ADDENDUM NO. 2

DATE: November 7, 2013

Contract 12-C-00042; Howard F. Curren AWTP Raw Sewage Pump Station Improvements

W.O. 4506
 SHEET
16

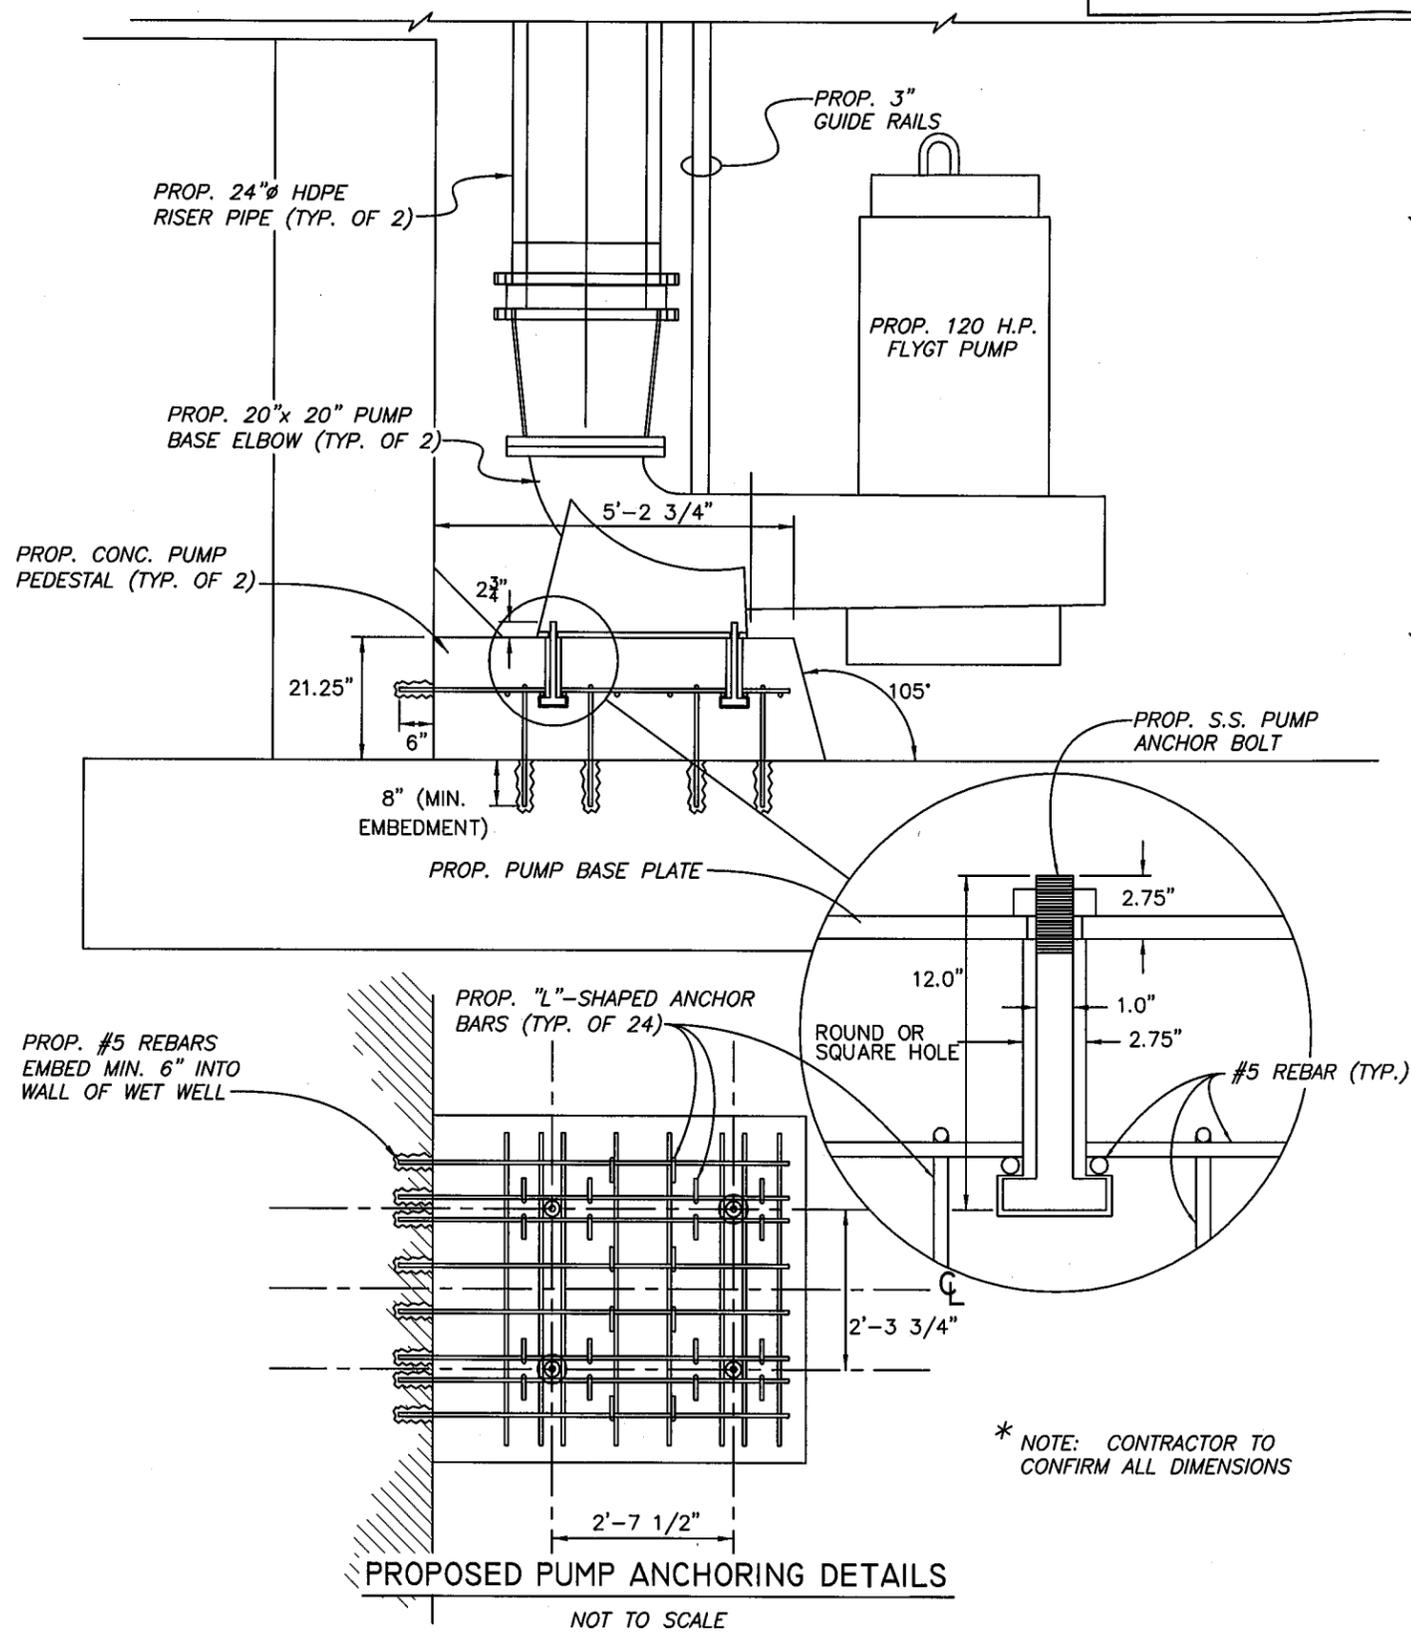
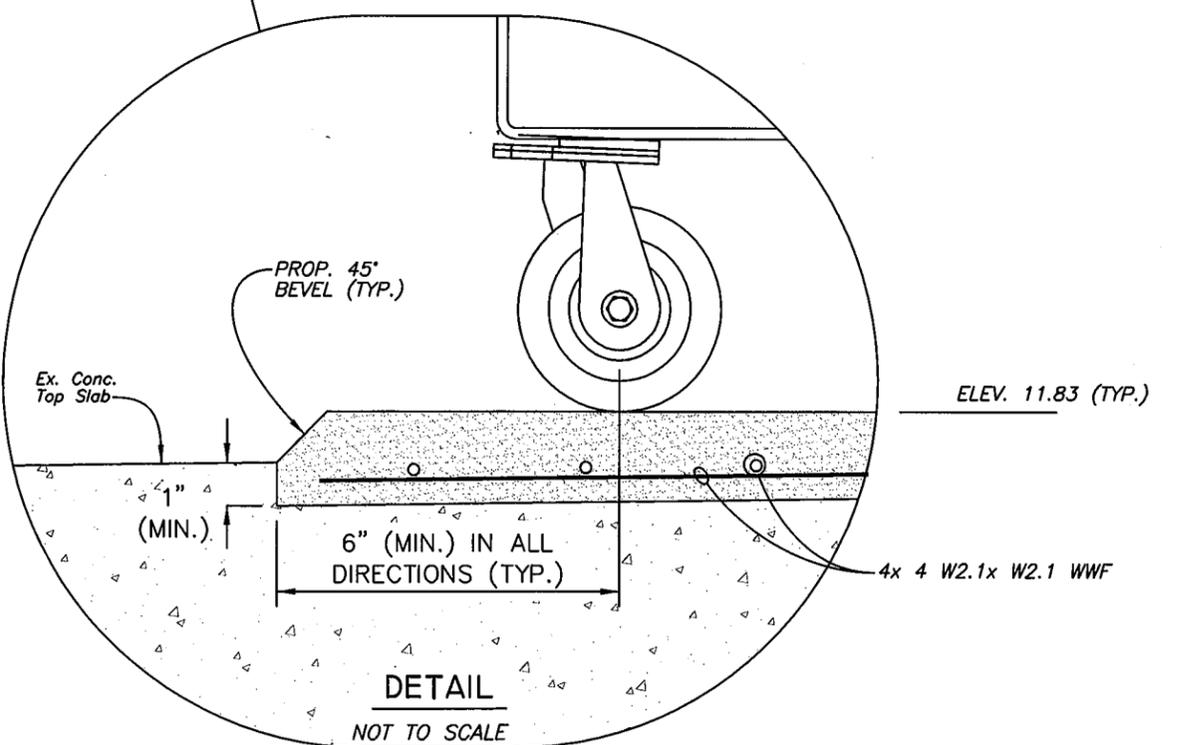
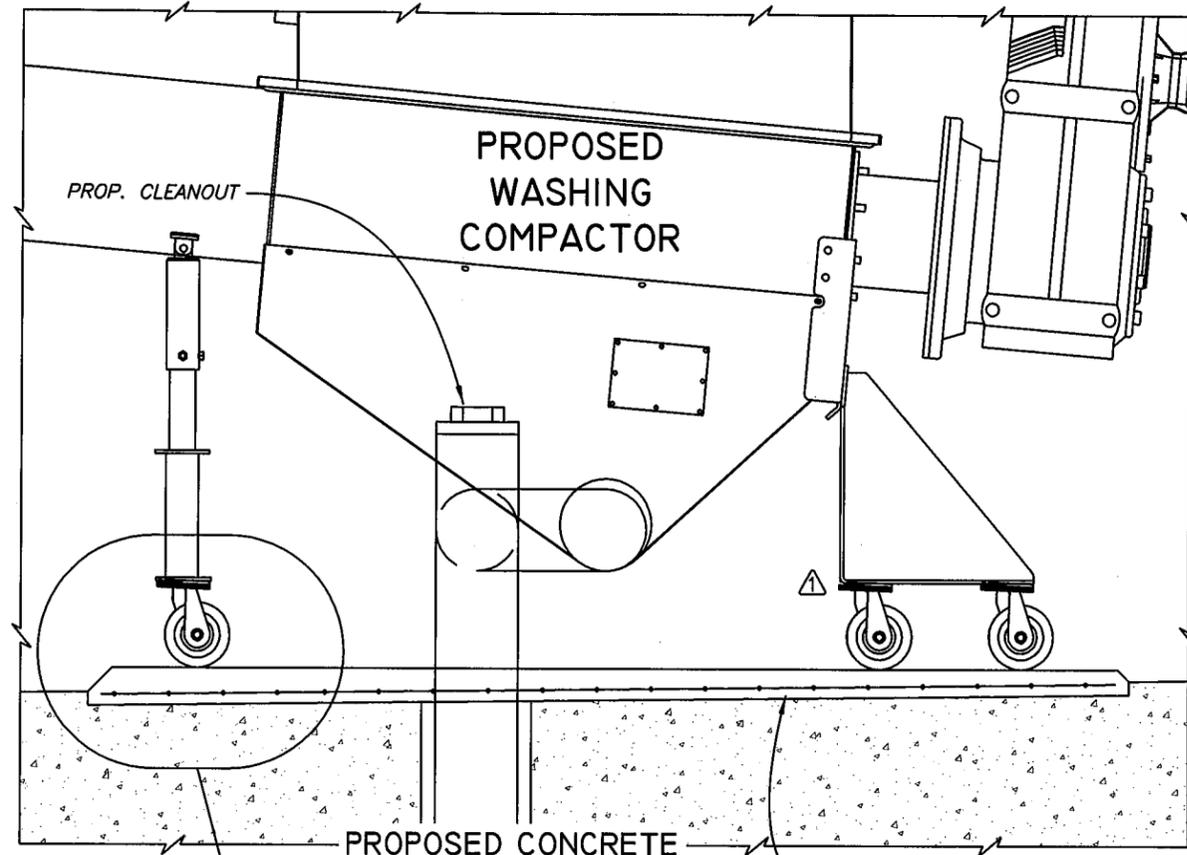
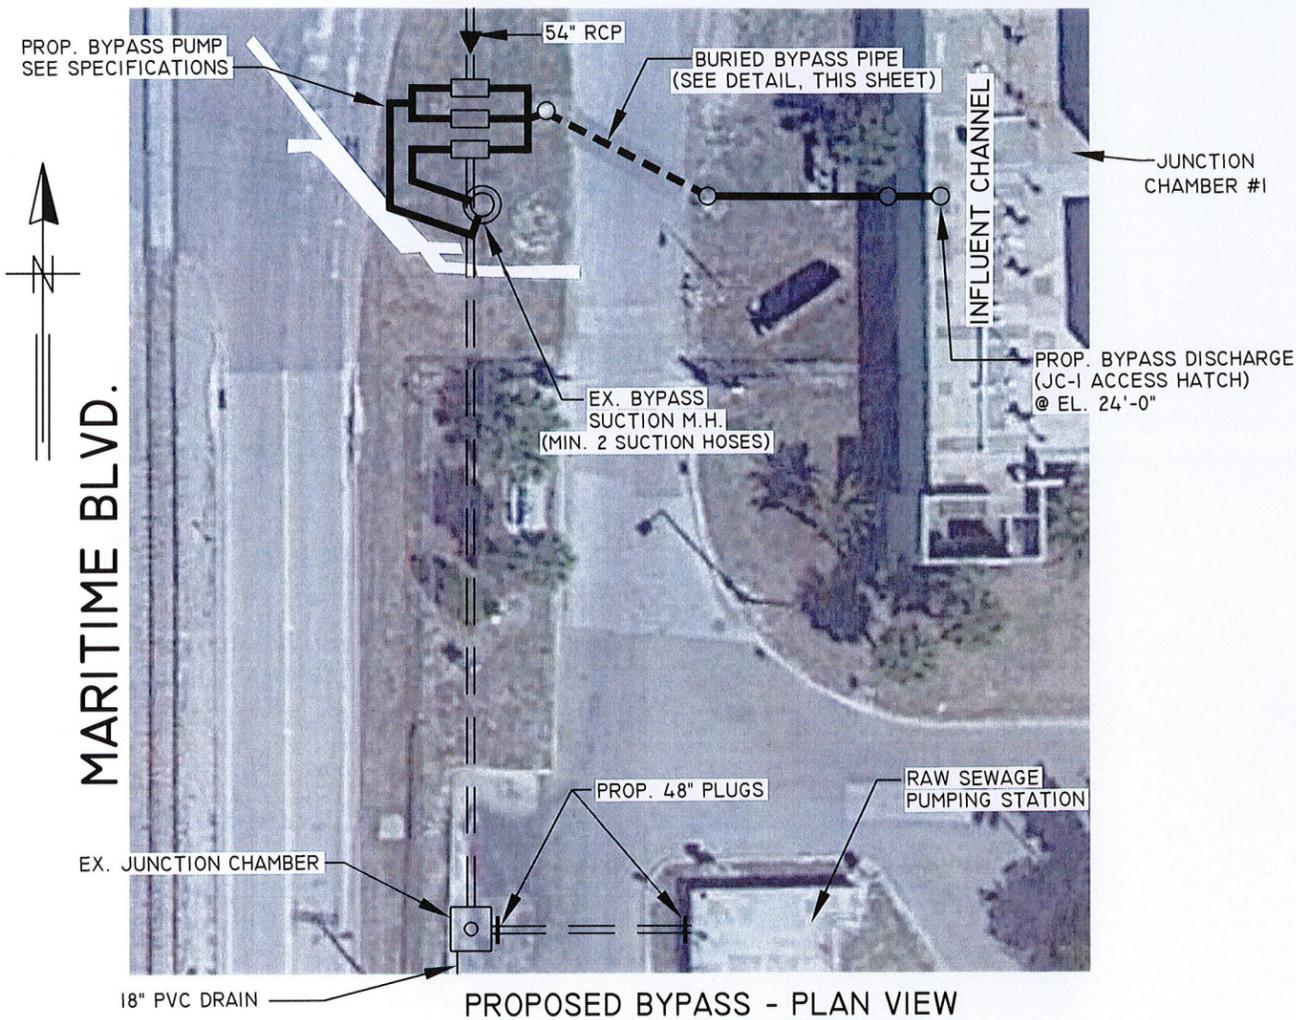
No.	DATE	REVISIONS
3		
2		
△	10/30/13	REMOVED UNWANTED LINE & REVISED LEVELING PAD NOTE

W.O. 4506
SHEET
18

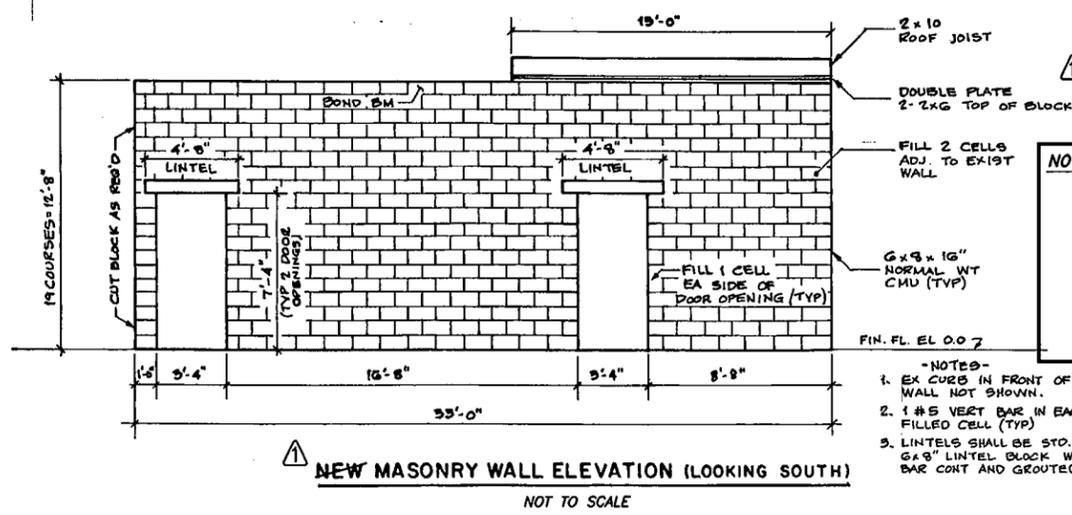
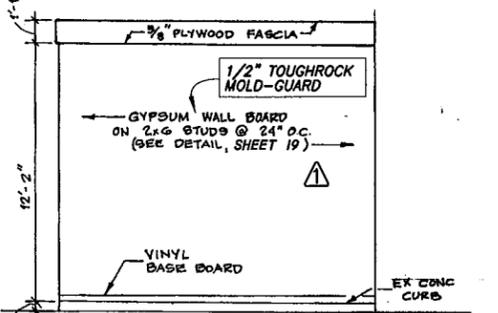
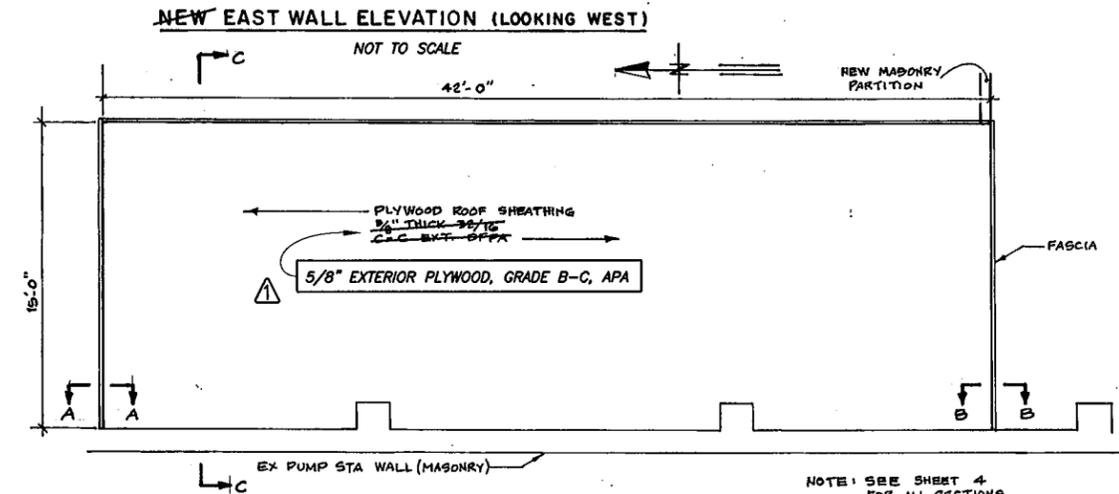
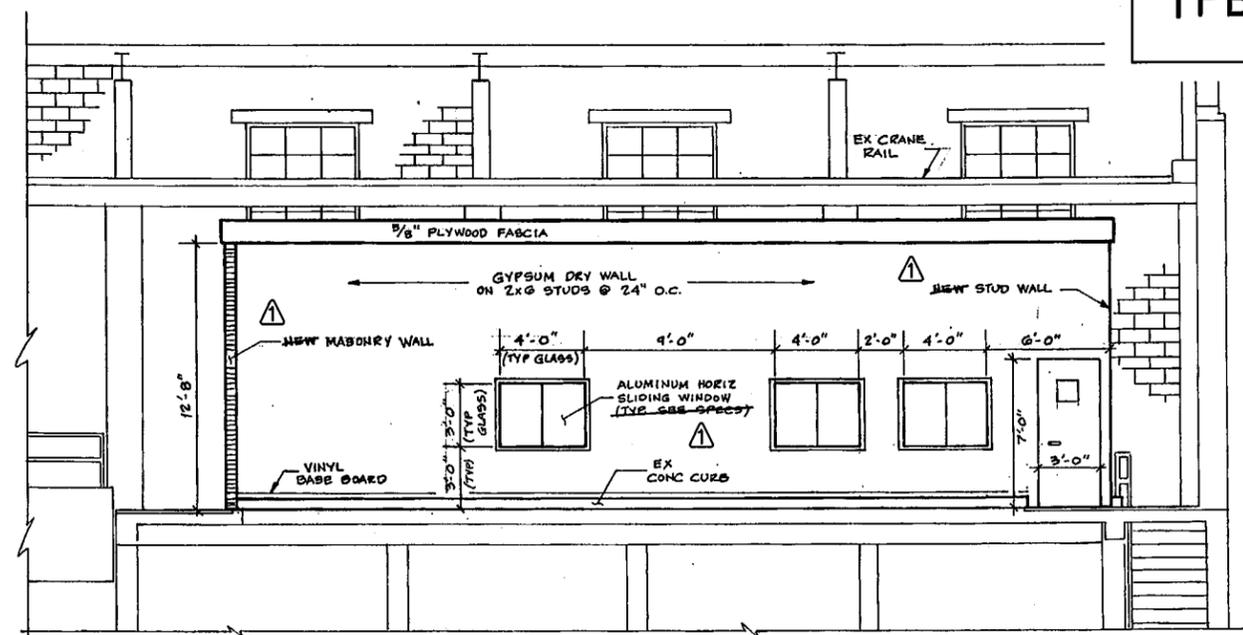
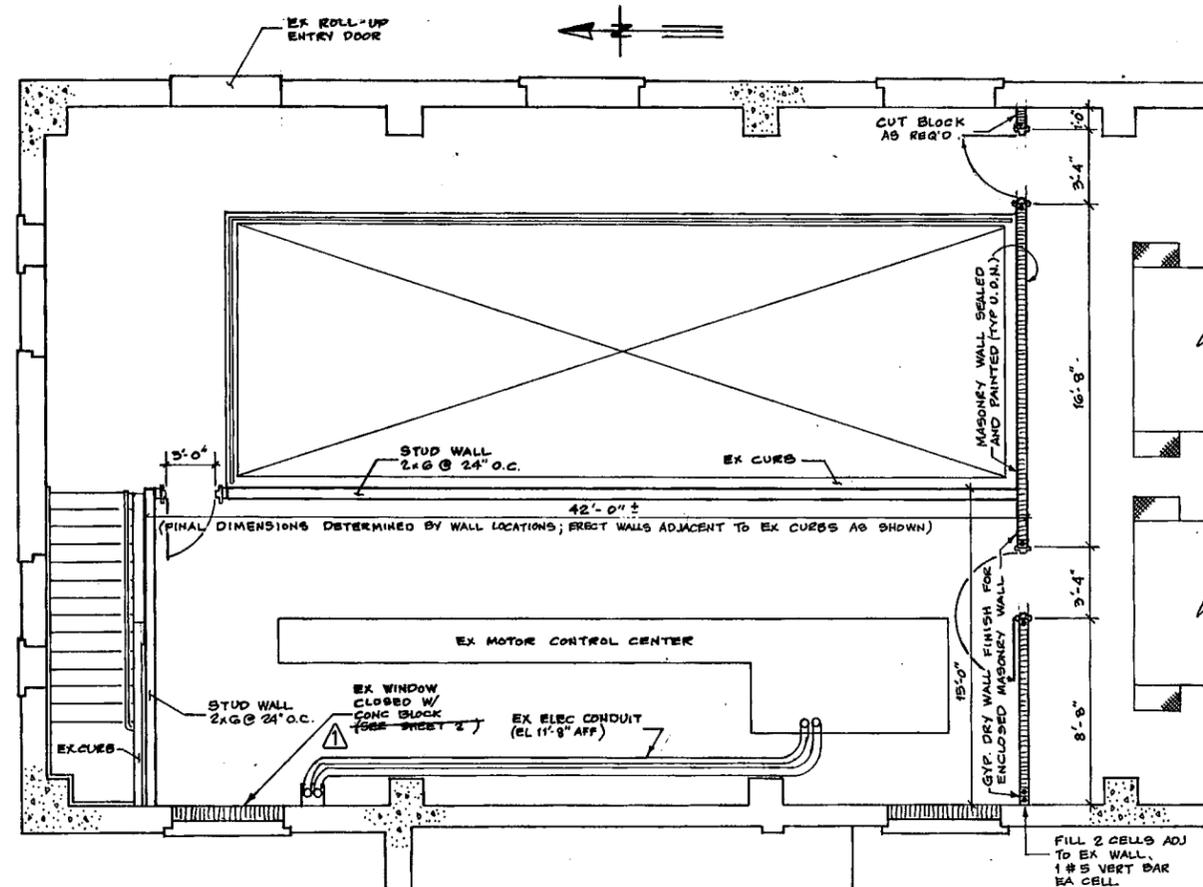
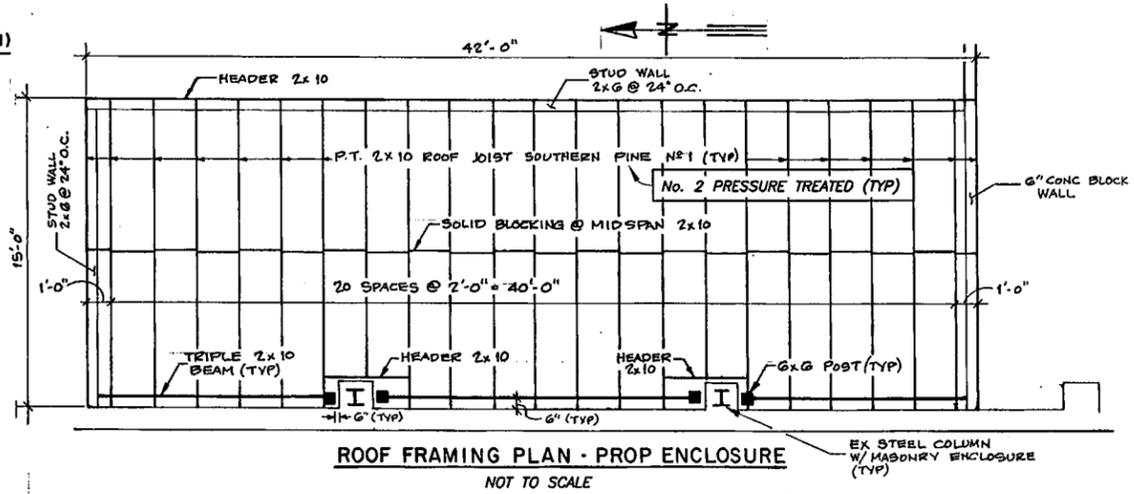
- Item 4: Existing T-Lok PVC Liner and Concrete Coating Clarification: The existing T-Lok PVC liner begins at elevation -11.60 and covers all existing concrete in the wet well above this elevation.
- Item 5: Masonry Clarification: Notes on plan sheets 18 and 19 are for informational purposes only. Masonry work is not anticipated on this project.
- Item 6: Bypass Plan Clarification: The drawing on Sheet 17 of the Plans is intended to show only the basics of the bypass pumping set-up: Where the suction manhole is and where the discharge pipe is. The Contractor is solely responsible for submitting the bypass configuration to the City for approval.
- Item 7: Manhole Dimensions: The manhole, shown on plan sheet 17, is 48-inches in diameter (I.D.) and approximately 18-feet in depth, from ground level down to channel invert.

No.	DATE	REVISIONS
3		
2		
1	11/05/13	REMOVED "NEW" DESIGNATIONS, REVISED NOTE, ADDED INFORMATION
